# Gatwick Airport Northern Runway Project

The Applicant's Response to the Examining Authority's  
Written Questions – Ecology and Nature Conservation

Application Document Ref: 10.16

**Figure 1 Mole Gap to Reigate Escarpment SAC and SSSI**

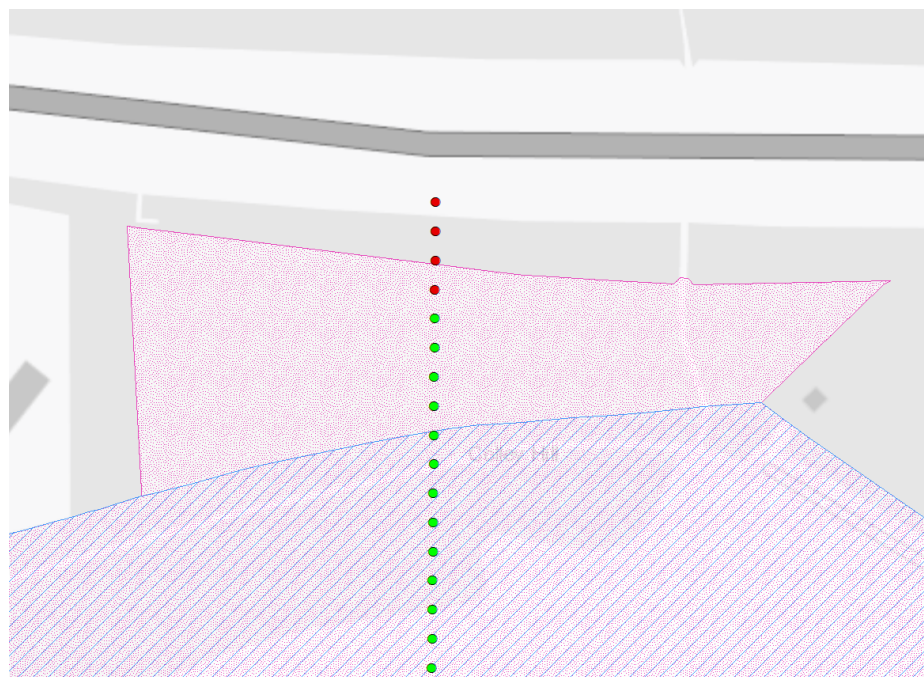
EN.1.26	The Applicant	<p><b>In-Combination Effects at the Mole Gap to Reigate Escarpment SAC</b></p> <p>The HRAR [APP-134] paragraph 4.5.54 states that the modelling did not predict any exceedances of the in-combination CLe for NO<sub>x</sub> and NH<sub>3</sub> at the Mole Gap to Reigate Escarpment SAC in 2032. However, this is not clear from Figures 40 and 41, which appear to depict exceedances in some locations.</p> <p>The Applicant is asked to explain the discrepancy.</p> <p>As explained in paragraph 4.5.53 of the <b>HRAR</b> (Doc Ref. 5.3 v2), the traffic data for this SAC shows that for the majority of the links the Project’s contribution to traffic flows is negative, and so there is no possibility of an in-combination effect along these links. The one link that does experience an increase in traffic in the in-combination assessment is the M25. However, in this location the exceedances fall within the SSSI</p>

boundary and not within the SAC boundary, and the habitats for which the SAC is designated do not occur in this location in any case (for note, in most areas the SAC and SSSI boundaries overlap, however close review of Figures and 40 and 41, shows the area of the SAC by way of a blue hatching, and the SSSI by pink dots) (see **Figure 1** below).

**Figure 2 A24**

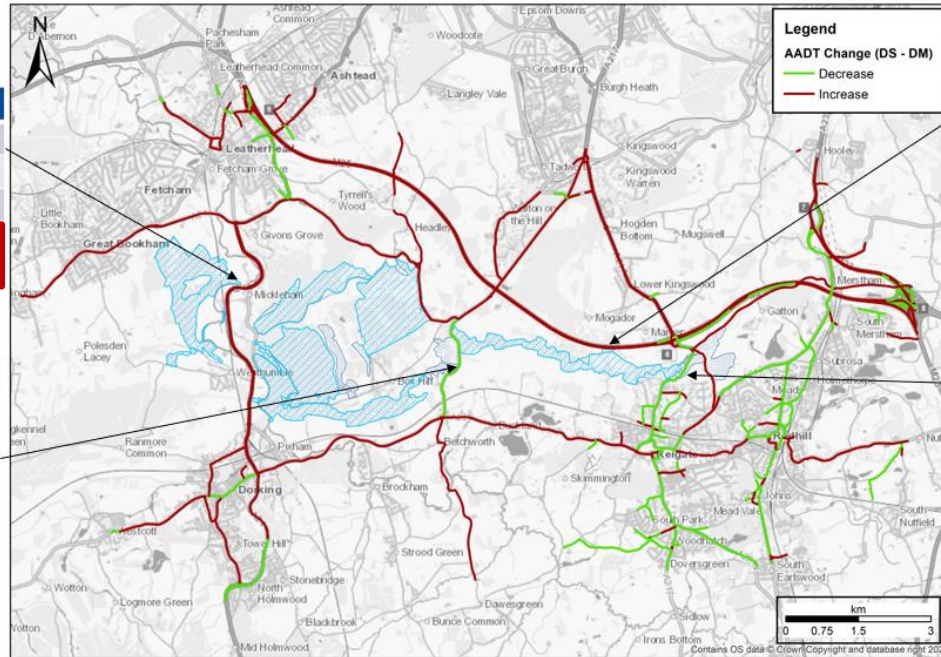
EN.1.31	The Applicant	<p><b>Changes in AADT</b></p> <p>In several of the HRA figures contained in HRAR Annex 7 [APP-135] the 'Diff (Main)' number equates to the 'Do Something' vehicle number minus the 'Do Minimum' vehicle number; and the 'Diff (Cumulative)' number equates to the 'Do Something' number minus the 'Do Minimum HRA' number (appearing consistent with the approach to the ICE assessment set out in HRAR paragraph 4.5.15). However, the opposite applies in other figures (and also to different roads within the same figure in some instances), ie the Diff (Main) number equates to the 'Do Something' number minus the 'Do Minimum HRA' number and the Diff (Cumulative) number equates to the 'Do Something' number minus the 'Do Minimum' number.</p>

<p>Can the Applicant explain this discrepancy and any implications it has for the assessment?</p> <p>The Applicant confirms that the traffic data used in the air quality modelling is consistent with the approach set out in Paragraph 4.5.15 of HRAR (Doc Ref. 5.3 v2).</p> <p>The HRA figures contained within <b>HRAR Annex 7</b> (Doc Ref. 5.3 v2) have been reviewed with respect to changes in AADT assessed in the air quality modelling. Errors have been identified in reporting difference values in Figure 10 for A24 and Figure 22 for Windsor Road. The corrected numbers have been provided below, highlighted by a red box at <b>Figure 2</b> and <b>Figure 3</b> below. The discrepancy in the figure values does not have any implications on the data used for the HRA assessment or on the conclusions reported.</p>
--	--	---
